Re: Additional Information for Forty Steps Coastal Bank Stabilization and Mixed-Sediment Nourishment, Nahant, MA. File Number NE 047-0610

On behalf of the Town of Nahant, Sustainable Coastal Solutions, Inc., is pleased to provide you with an update and further information on the Forty Steps Coastal Bank Stabilization project. A design change was required due to a change in the construction access at the project's southern boundary. When the project was originally submitted to the Conservation Commission for review, the construction access was along the southern boundary of the project on an adjoining parcel of privately owned land. The town was granted deeded access through the lot to protect the coastal bank at Forty Steps Beach in 1962. The Town has used the access point several times since deeded access was granted to conduct maintenance on the coastal bank. The current owners of the property have requested that the Town not utilize the deeded access to stabilize the coastal bank. They also requested that the Town not stabilize the eroding coastal bank on their property. The Town evaluated various access points and methodologies again and modified the original project design to

Figure 2. Cross-shore plot of a typical cross-section through the mixed sediment nourishment and the existing beach profile.

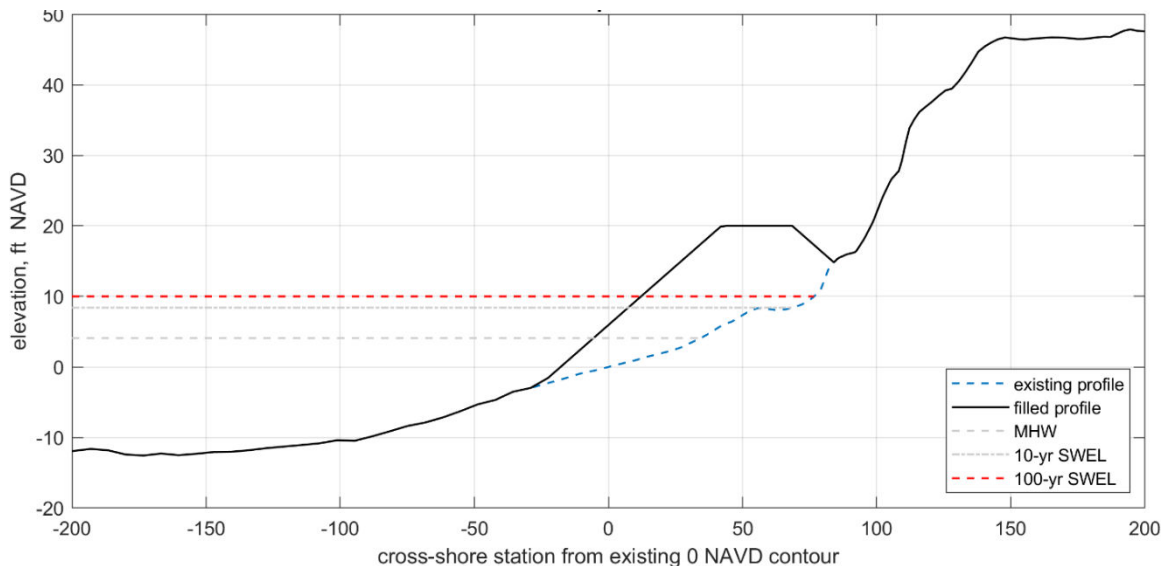
The mixed sediment nourishment has had one minor alteration, which involves reducing the extension of the construction template beyond the Town property line. The overall design of the simplified construction template remains the same. The back slope remains tied into the crest of the seawall and slopes upward on a 3:1 (h:v) slope, with a flat berm crest 26-feet wide at elevation 20 feet NAVD88, and a 3:1 (h:v) foreshore slope to the existing beach as shown in Figure 4.1. The template design still represents approximately 34.7 cubic yards of nourishment sediment per linear foot, or 17,000 cubic

yards of sand, gravel, and cobble. The southern edge of the construction template has been modified so that no nourishment is placed beyond the Town property boundary at the base of the ledge outcropping. However, due to the dynamic nature of mixed-sediment beaches, the material once on the beach, will naturally migrate due to incoming waves and fill the entire beach face as it transitions into the natural equilibrium profile. The minor change to the construction template will not negatively impact the beach's enhanced ability to dissipate and disrupt the incoming wave energy by adjusting its morphology in response to the prevailing tide and wave conditions.
